**Addendum to IFB**

**IFB TITLE:** Crane Bayou Pump Station Generators and Building – Community Development Block Grant-Disaster Recovery (CDBG-DR) Program Project for Jefferson County

**ADDENDUM NO.:** **3**

**Reason for Issuance of this Addendum: CLARIFICATIONS, PAGE REPLACEMENT, WAGE RATES, AND GEOTECHNICAL REPORT**

Replace sheet C-2 with the attached sheet C-2.

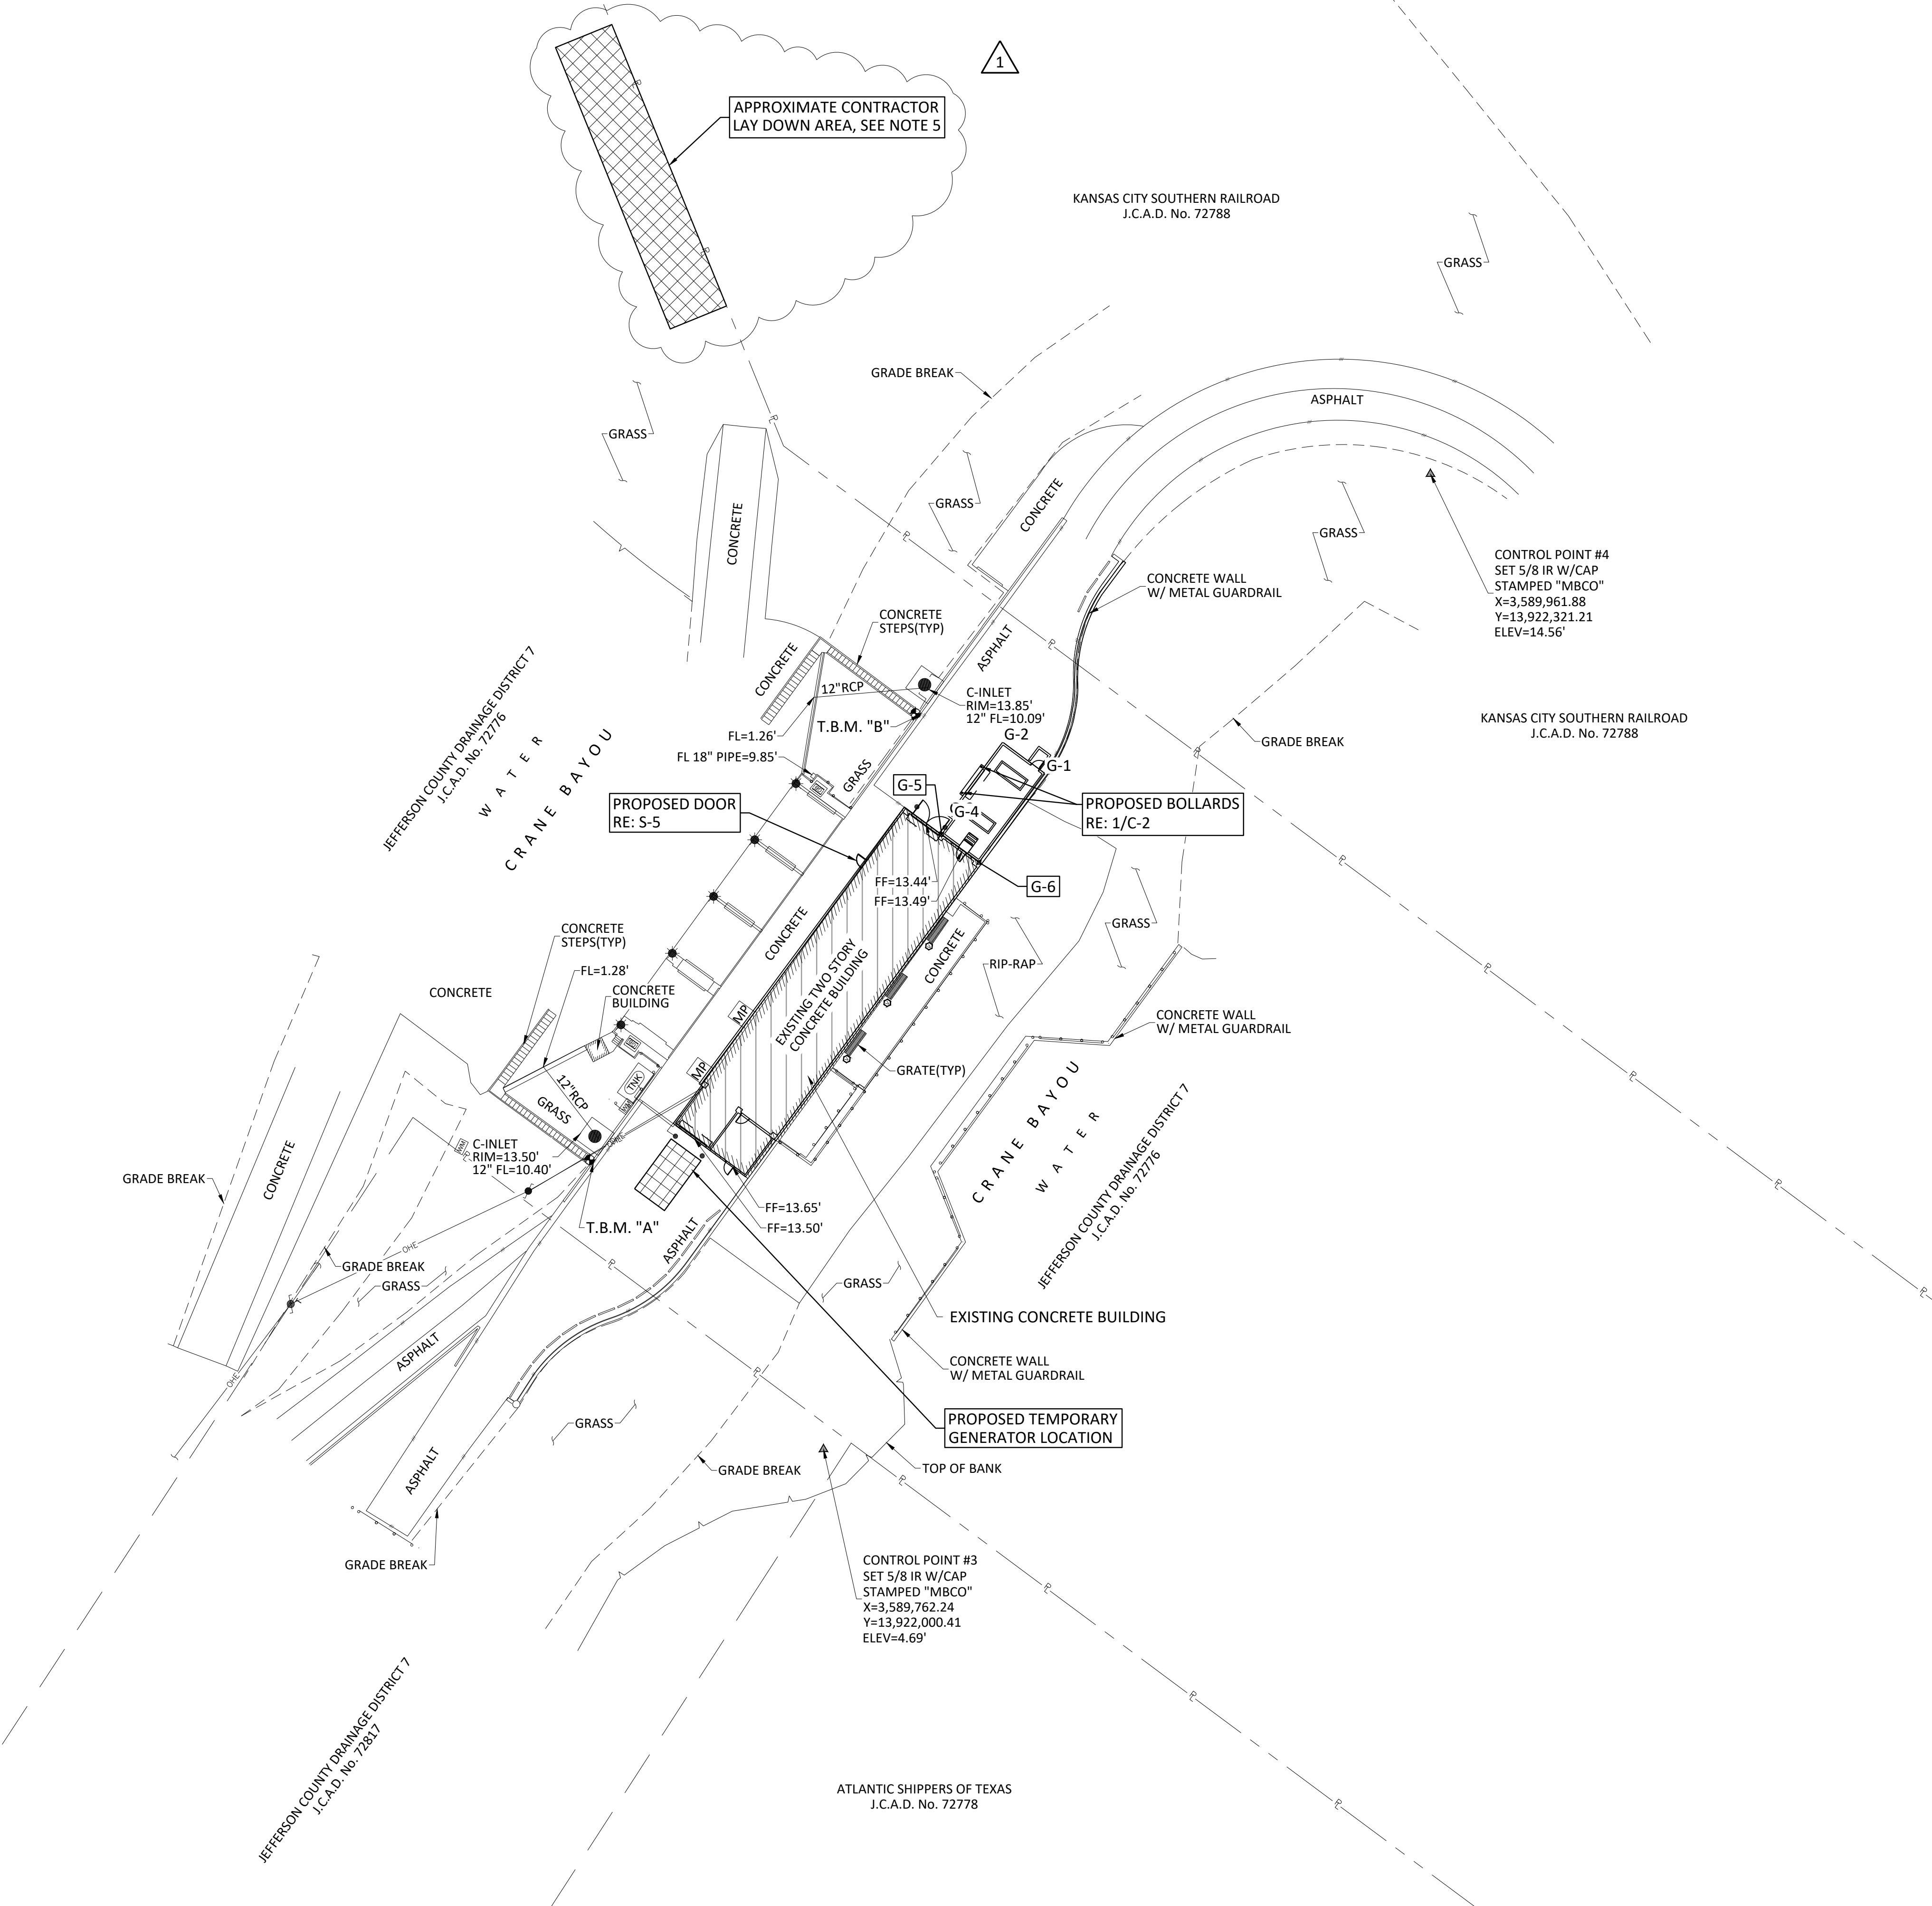
**Question:** On sheet C-2 it states we cannot park a vehicle larger than a 3/4" ton vehicle on the level or within the toe. Can you clarify the intent of this note as this will impact construction? Will we be able to bring concrete trucks on the levee? What about setting up a crane to set the generators and concrete roof panels? We will likely need large equipment within the toe for the majority of the project.

**Answer:** The intent of this requirement is to mat heavy loads. Specifically, heavy loads such as concrete trucks or tractor/trailers crossing the pump station intake will need to be matted. Cranes will also need to be matted.

1. CONTRACTOR SHALL NOT PARK ANY VEHICLE LARGER THAN A 3/4 TON TRUCK ON TOP OF THE LEVEE OR WITHIN THE TOE (INDICATED BY A GRADE BREAK ON THIS SHEET) WITHOUT WRITTEN APPROVAL FROM THE OWNER.
2. EQUIPMENT AND VEHICLES LARGER THAN A 3/4 TON TRUCK MAY STAGE ON THE LEVEE FOR THE PURPOSES OF LOADING AND UNLOADING ONLY.
3. CONTRACTOR IS CAUTIONED THAT THE OWNER WILL BE OPERATING THE PUMP STATION THROUGHOUT CONSTRUCTION AND SHALL KEEP ROADWAYS AND ACCESS POINTS CLEAR TO ALLOW FREE MOVEMENT FOR OWNER'S OPERATIONS AND MAINTENANCE STAFF.
4. TEMPORARY GENERATOR SHALL BE TRAILER MOUNTED. CONTRACTOR SHALL COORDINATE WITH OWNER IF GENERATOR NEEDS TO BE TEMPORARILY RELOCATED TO ALLOW ACCESS TO THE SOUTHWEST ROLL UP DOOR.
5. CONTRACTOR MAY USE JEFFERSON COUNTY DD7 PROPERTY FOR LAYDOWN AREA ABOVE ELEVATION 8 FEET.
